**AMENDMENT TO REQUEST FOR
PROPOSAL / MODIFICATION DE
DEMANDE DE PROPOSITION**

| Furniture Products | |
| 1000357679 | 2021-06-24 |

SOLICITATION AMENDMENT # 002

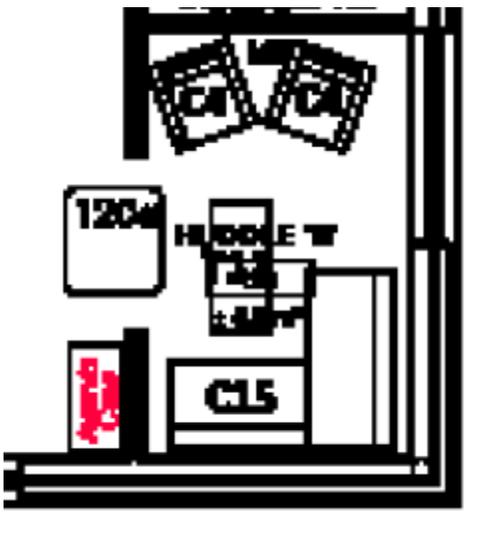
- Q23.** Category 3 : Collaborative & support space furniture, item #C15, would the customer accept a total width of 56.3"?
- A23.** Yes this total width is acceptable as long as the width of individual curvilinear bench seating units at the widest edge does not exceed 55" in accordance with the detailed requirements under section 6.6.21 of APPENDIX C: Furniture Technical Requirements.

IMPORTANT: the floor plan image may be misleading. C15 includes both the object C15 and the rectangular object immediately to its right (see below).
